**PENTAGON  
RELOCATION OF PENTAGON METRO ENTRANCE**  
Arlington County Virginia

Report to the Department of Defense

March 1, 2001

MEF FLOOR PLAN

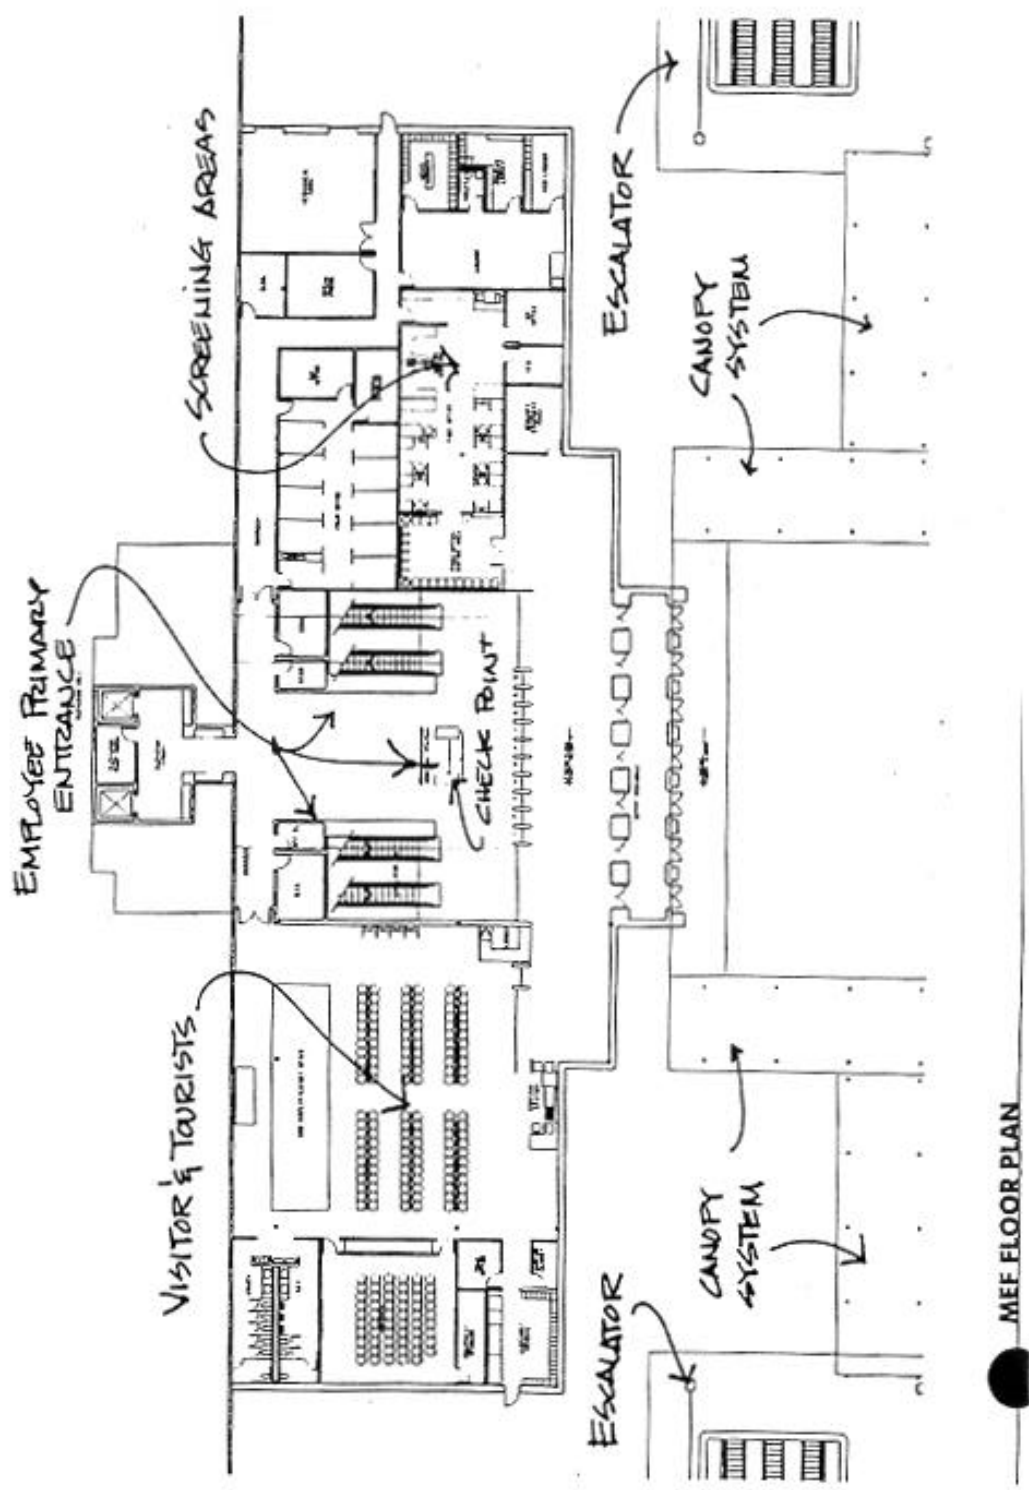
The new entrance addition allows for required security in that this entire structure can be sealed-off in the event of a crisis or threat. It provides a consolidated point of arrival for screening and security checks prior to actually entering the Pentagon Building. Further, this structure also contains services for visitors and tourists. Some of these services include an auditorium, display space, vending area, and a tour office. This structure should greatly enhance the visitor experience.

EXTERIOR RENDERING

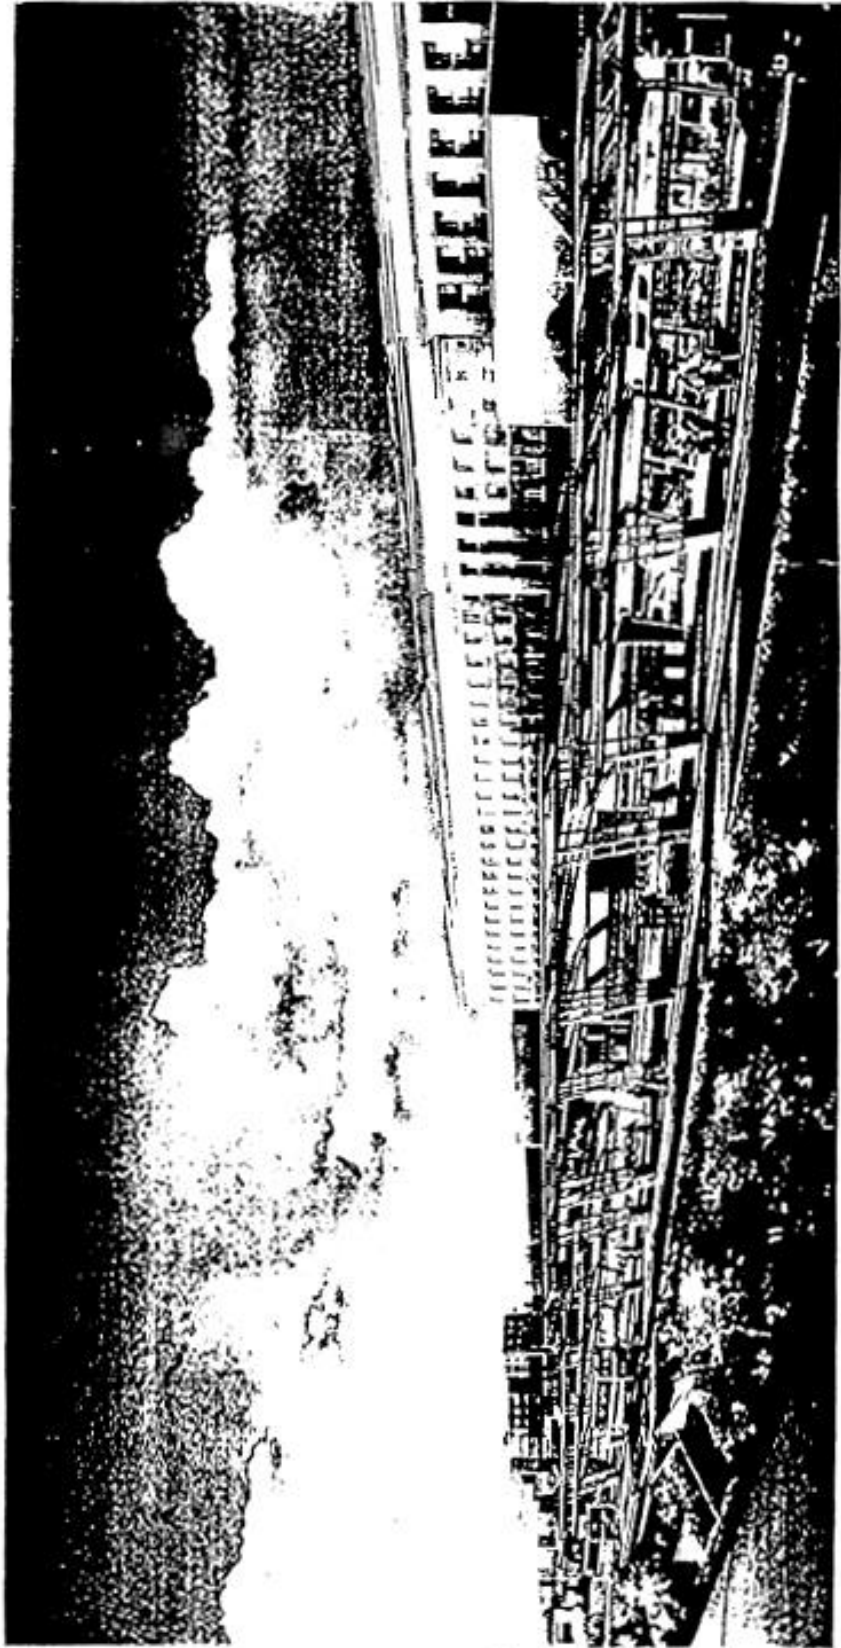
The design of the addition results in a limestone structure that draws its material reference from the existing Pentagon Building and the new canopy structure. As such, it becomes a transition element from the more traditional architectural vocabulary of the Pentagon Building to the very contemporary forms of the canopy system. It respects the architectural vocabulary of the existing Pentagon Building.
